## PLANNING COMMISSION MEETING PACKET CONTENTS

1. Agenda
2. Special Meeting & Public Hearing Notice – Site plan review and special land use application for Mead Johnson & Company, LLC – 725 E Main Ave

**RE:** **May 11<sup>th</sup> Special Planning Commission meeting agenda – Site plan review and special land use application for Mead Johnson & Company, LLC – 725 E Main Ave – Campus modernization project**

## **Mead Johnson Nutrition – Zeeland Modernization Masterplan**

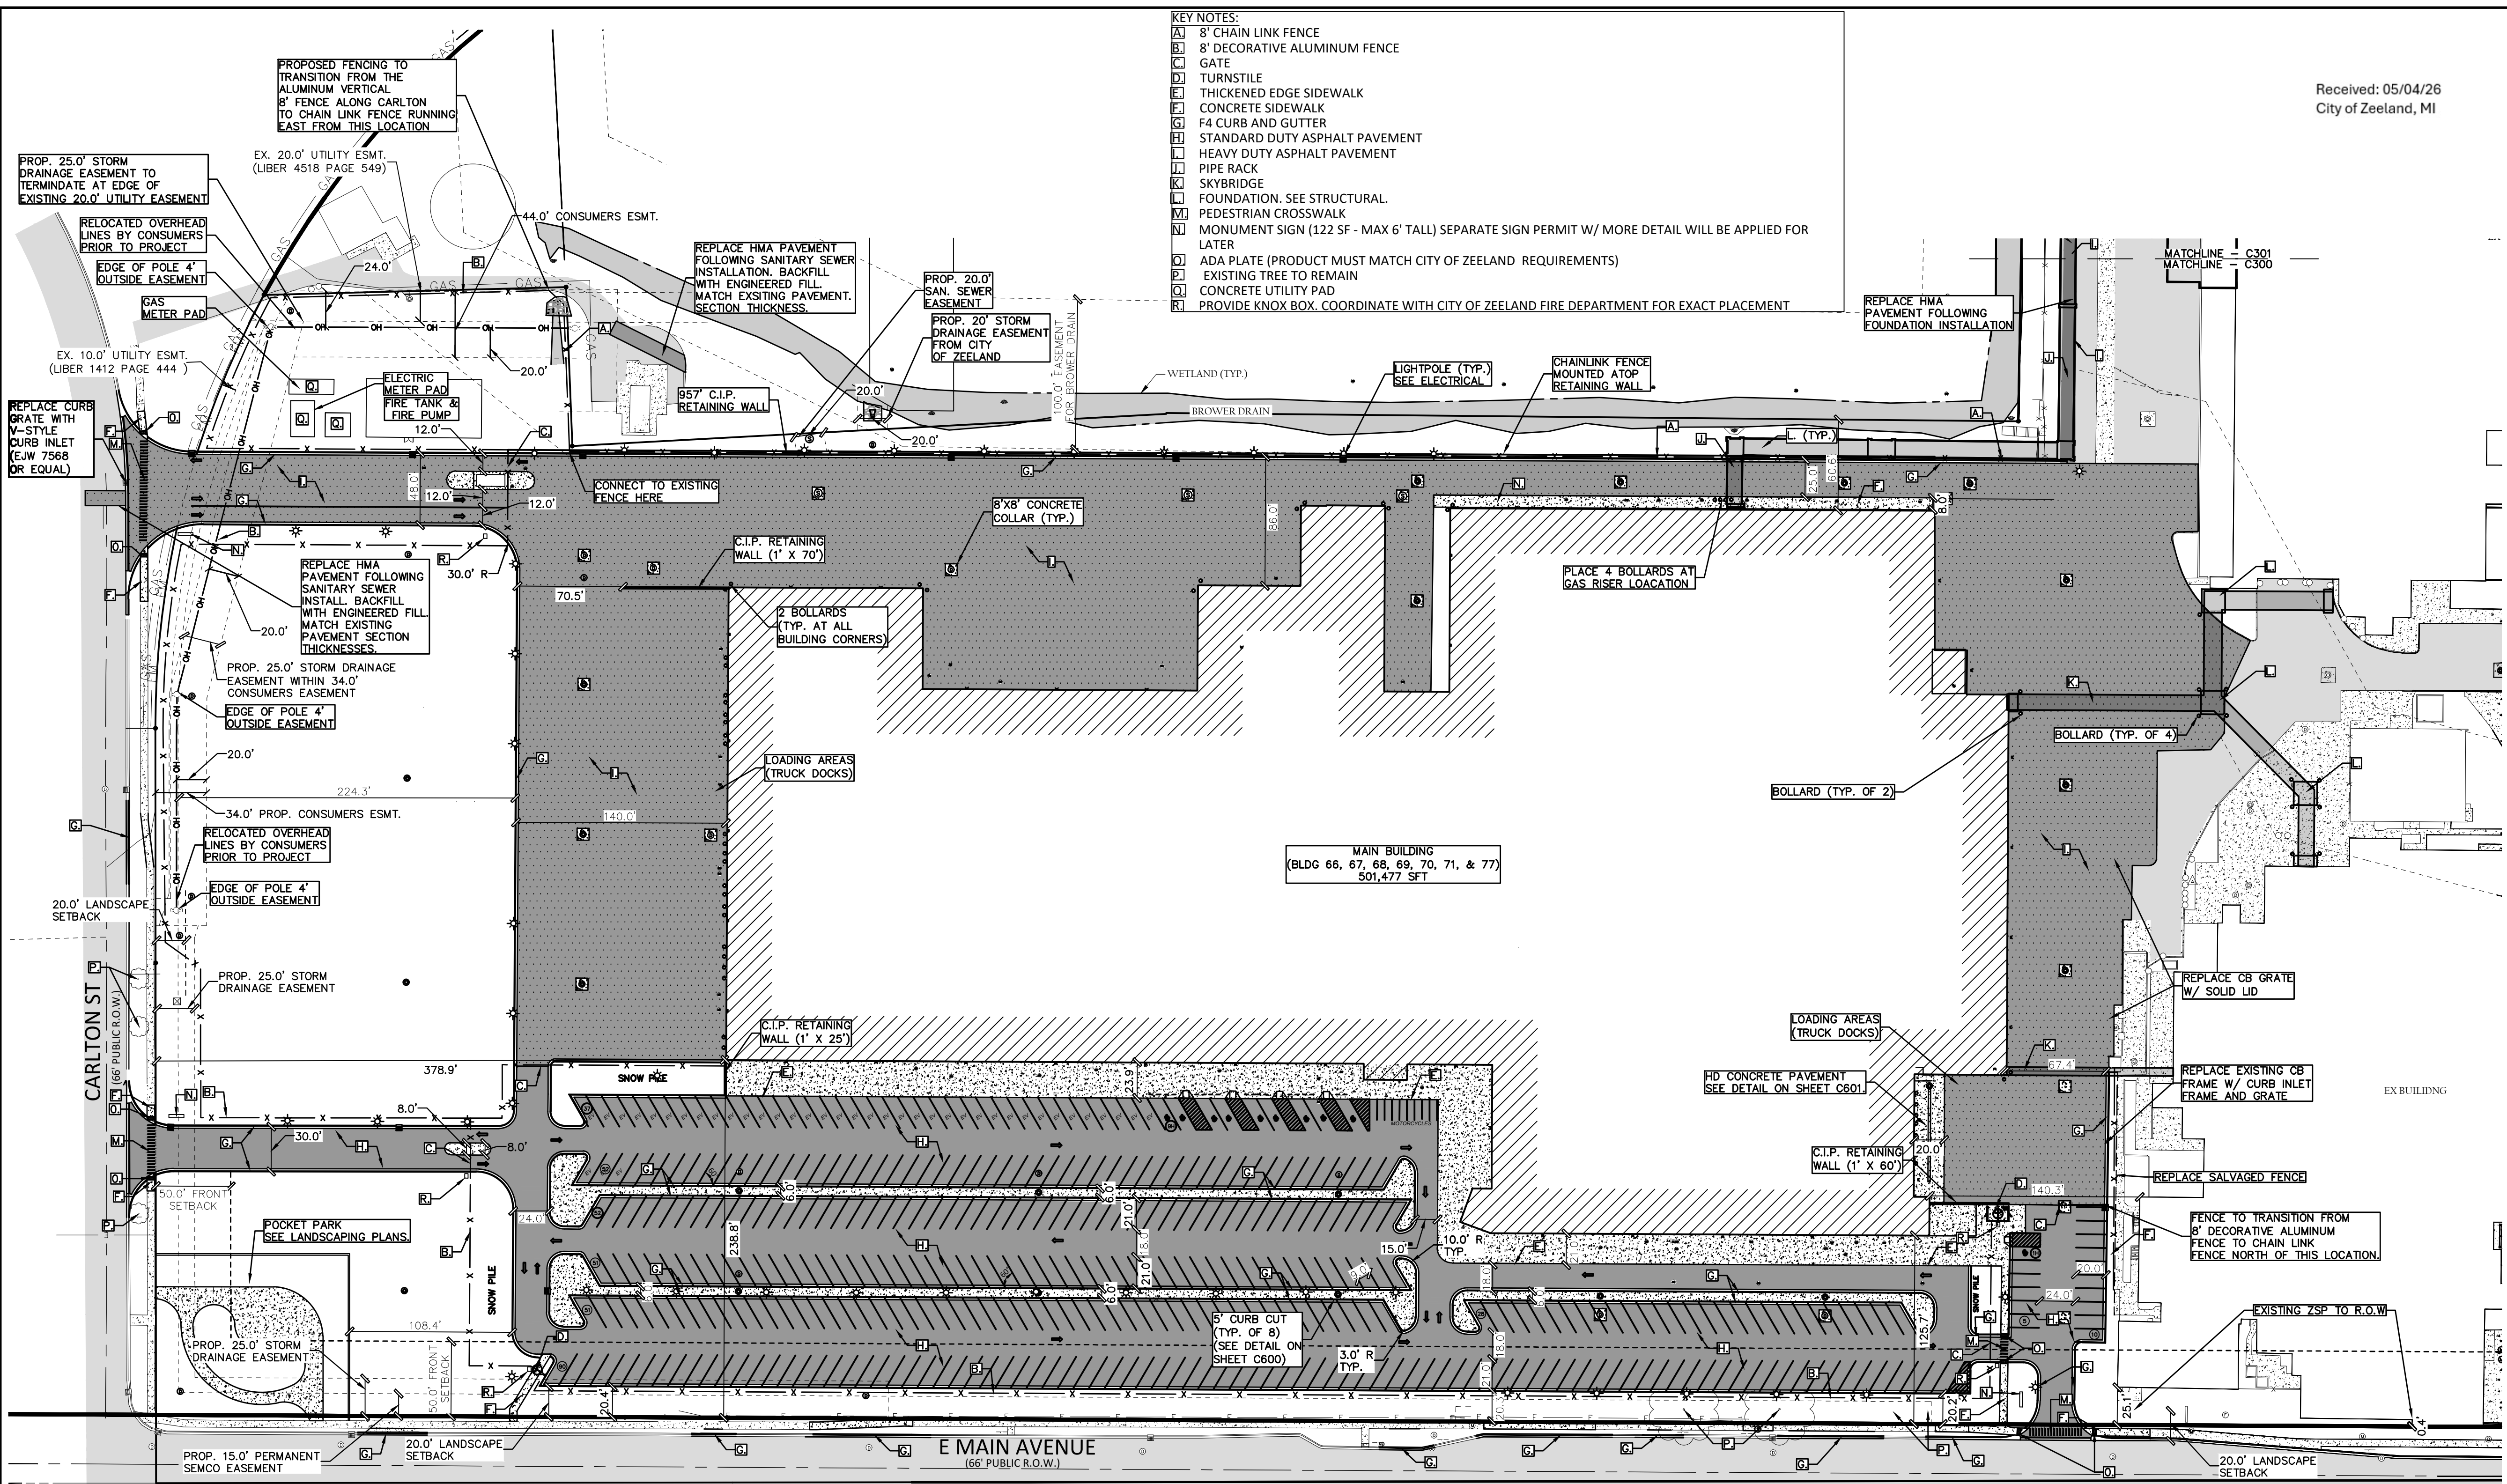
- Remove unnecessary drive openings along Main Street and restore these areas with curb and gutter  
VK Civil has revised the plans to remove existing curb cuts that will no longer be utilized. High back curb and gutter will be replaced in areas that previously had flush V-style gutter at curb cuts. See sheet C200 for additional demolition items. See sheet C300 for proposed changes.

- Provide dimensioning to demonstrate compliance with the required 20-foot parking setback.  
VK Civil has added additional dimensions to sheet C300 indicating the 20' parking setback is met.

- Revise labeling along Carlton Street where two trees are currently identified as "A - Chain Link Fence."  
VK Civil has revised the plans to correct this issue. See sheet C300.

- Adjust the transition point from aluminum fence to chain link fence along Carlton so that it occurs at the back corner where the fence continues south.  
VK Civil has revised the plans to accommodate the above request. See sheet C300.

SHEET # 230501-1473-C400-UTILITY PLAN  
 DRAWING NUMBER: C400  
 SHEET: 16 OF 40

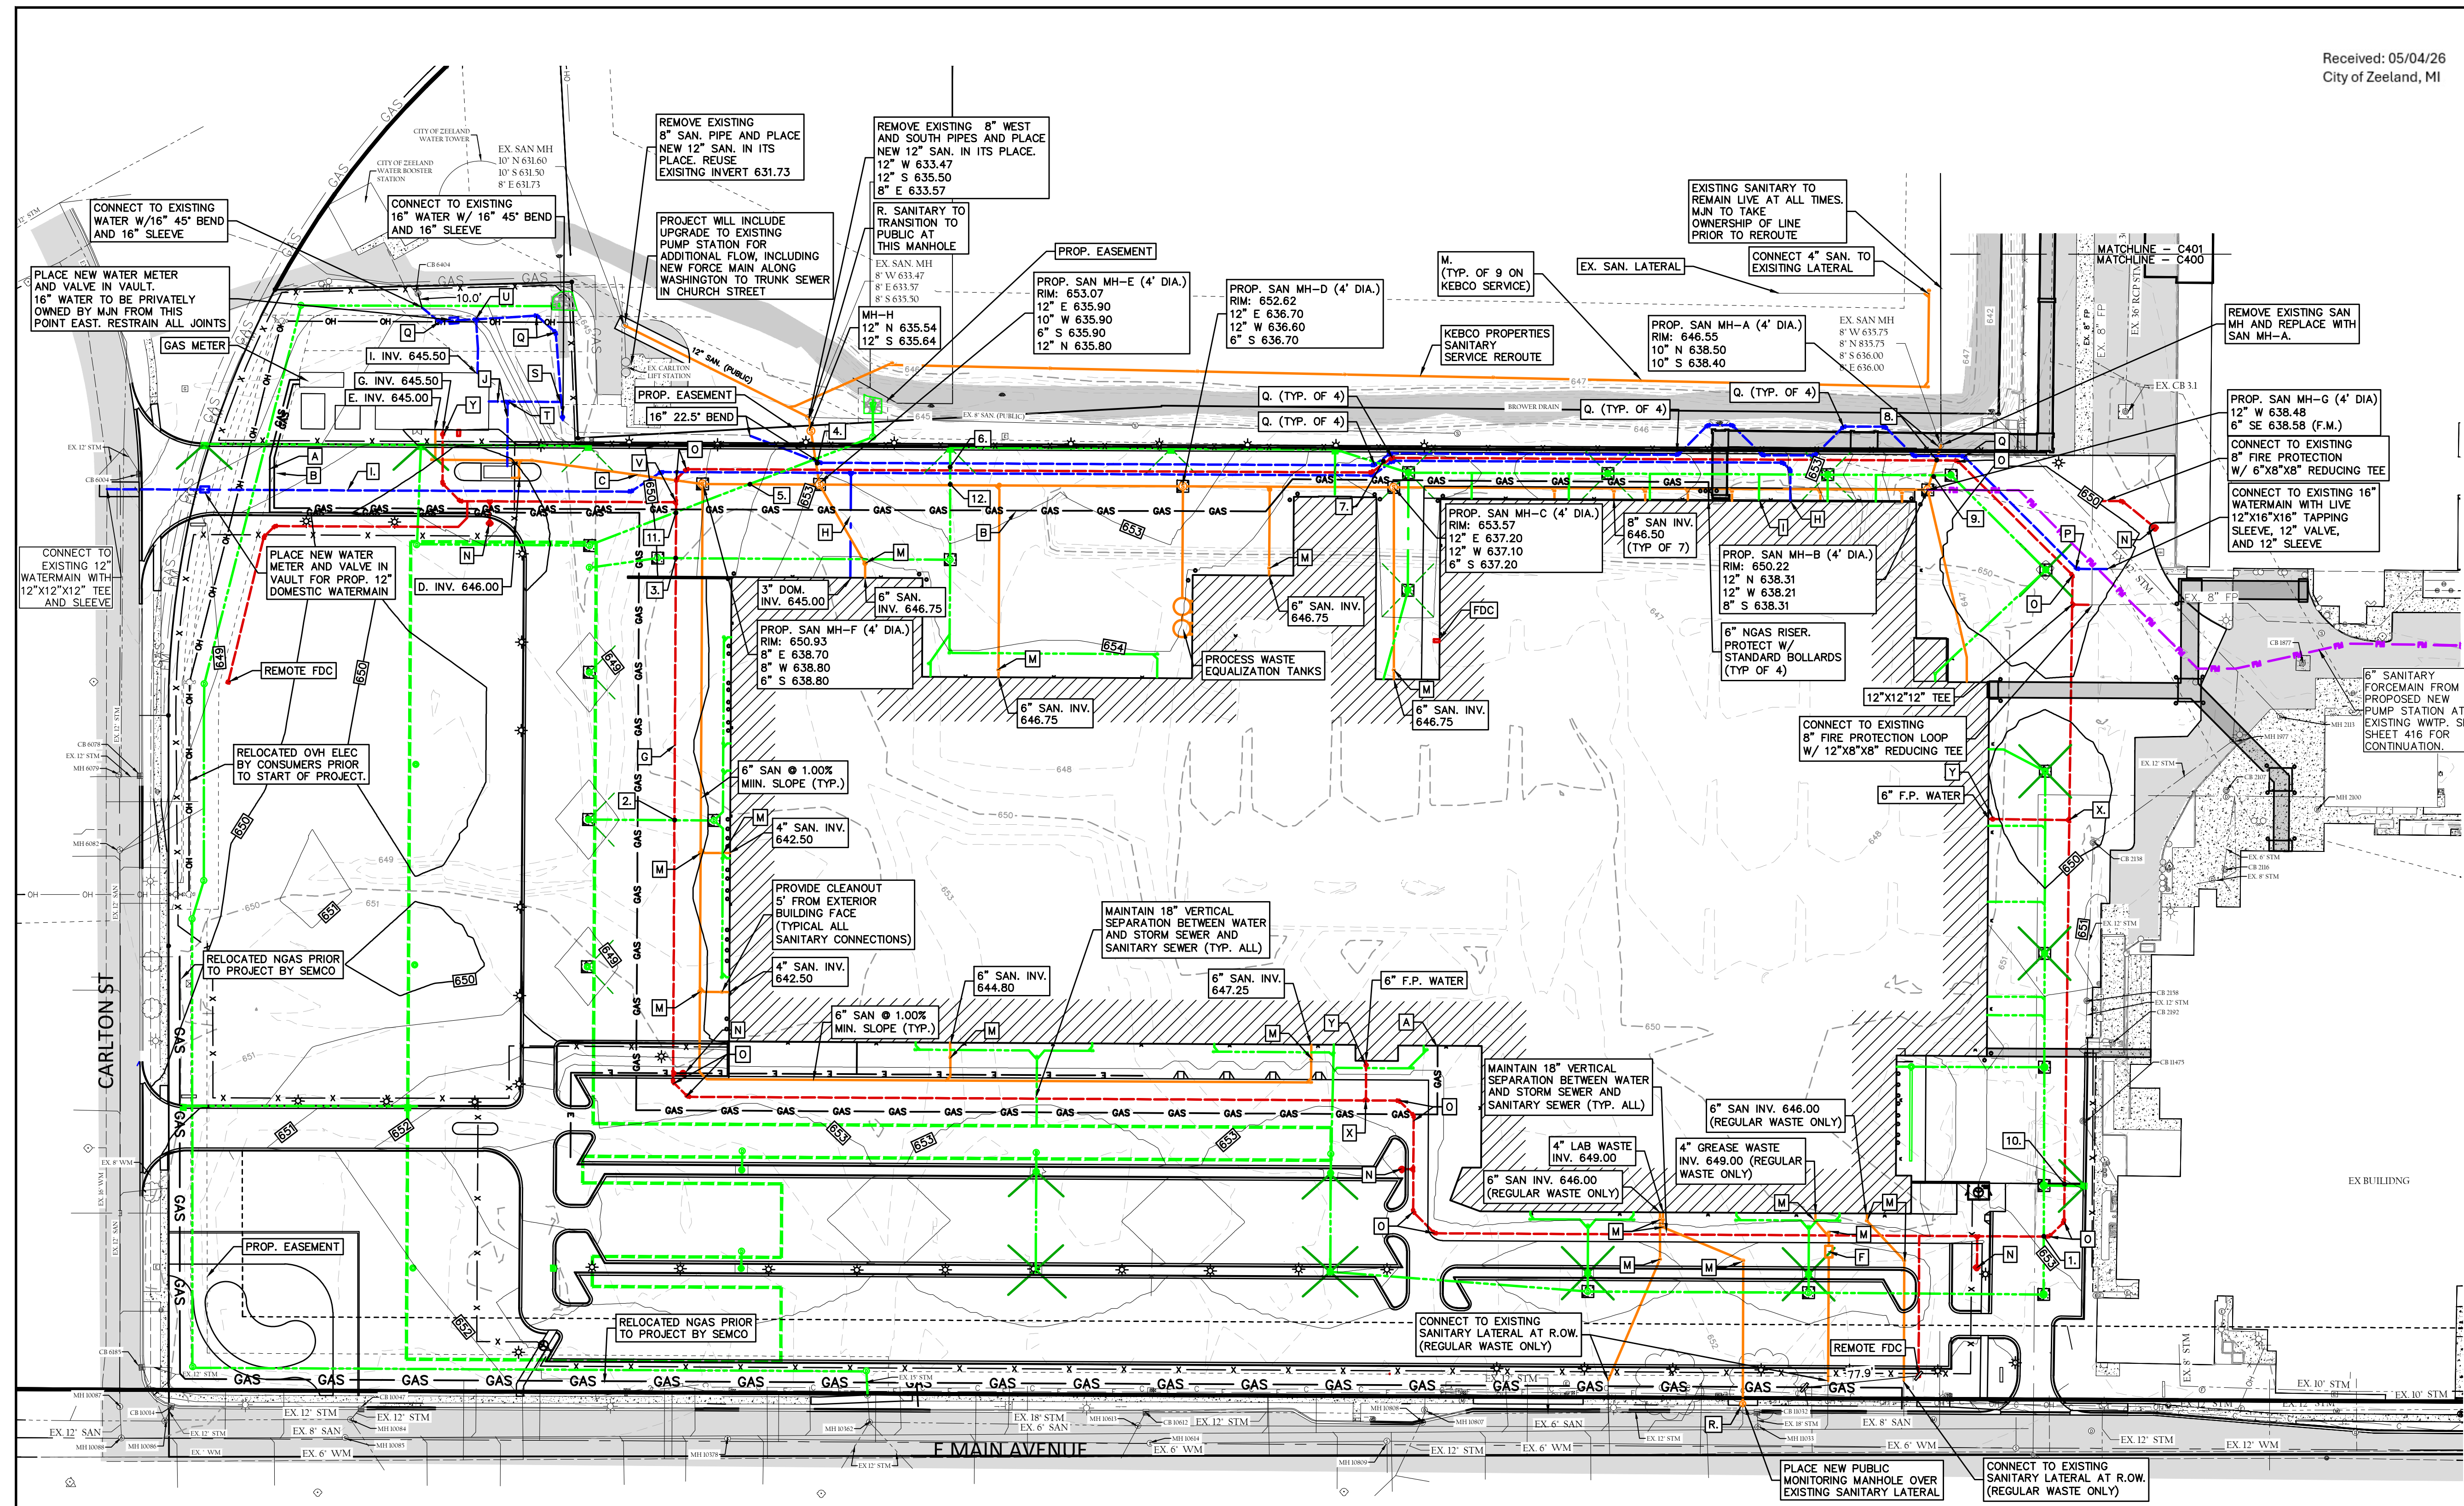
- Show existing features on utility plans including the Brower Drain, water tank, and booster pump station.  
Existing features including Brower Drain, water tank, and booster station have been labeled on the plans. See sheets C200 and C400.
